Duane Arnold Energy Center  
Docket 50-331  
License No. DPR-49

Monticello Nuclear Generating Plant  
Docket 50-263  
License No. DPR-22

**Request for Additional Information Regarding Authorization to Use Code Case N-613-1**

### REQUEST FOR ADDITIONAL INFORMATION DUANE ARNOLD ENERGY CENTER - TAC MC2374 MONTICELLO NUCLEAR GENERATING PLANT - TAC MC2375

FIG. 2 NOZZLE IN SHELL OR HEAD  
 (Examination Zones In Flange Type Nozzles Joined by Full Penetration Butt Welds)

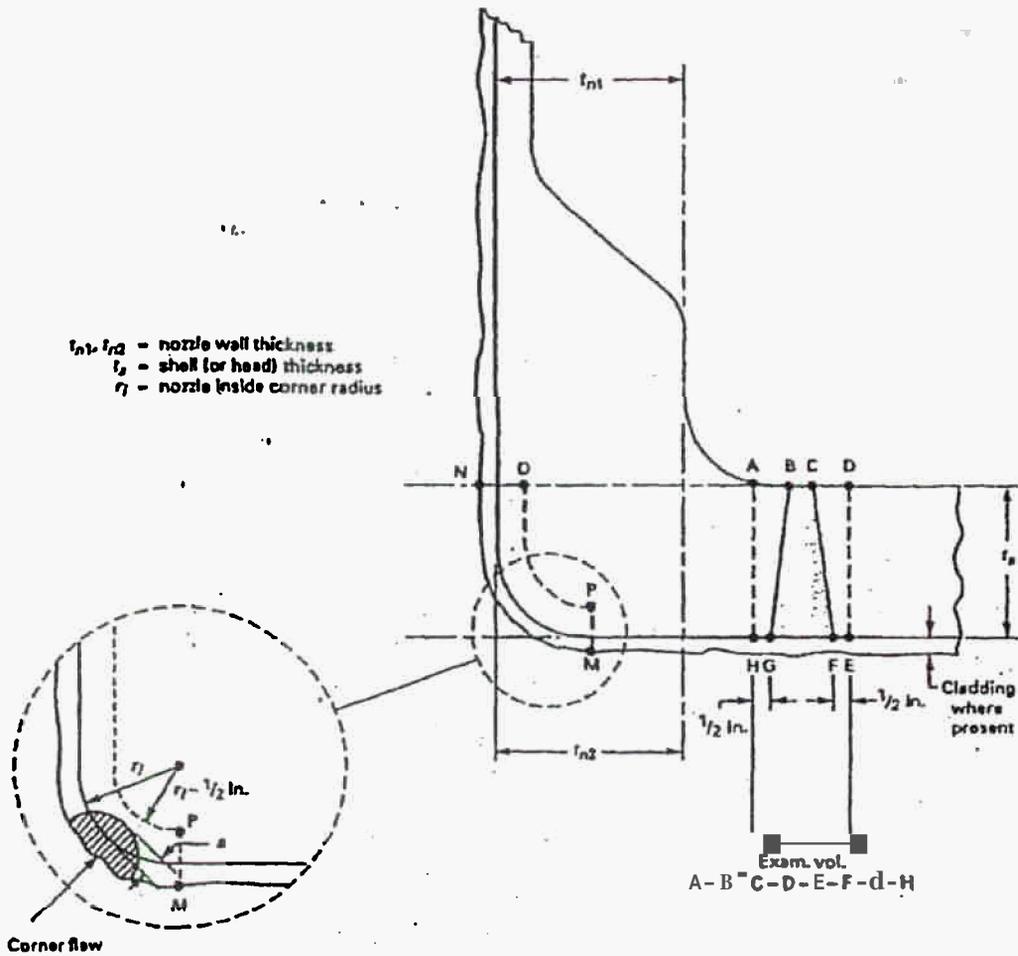
1. In Item 5, "Proposed Alternatives and Basis for Use," of NMC's letter of February 27, 2004, states that the "required examination volume for the RPV [reactor pressure vessel] nozzle-to-vesselwelds extends far beyond the weld into the base metal, and is unnecessarily large." This proposed alternative would redefine the examination volume boundary to one-half inch of base metal on each side of the widest portion of the weld.
  - a. Please provide a supplemental sketch showing the specific configuration nozzle-to-vesselweld and revised examination volume (including dimensions).

All of the welds for which use of the Code Case is requested are of the configuration shown in Figure 2 of the Code Case. (See Enclosure 2.)
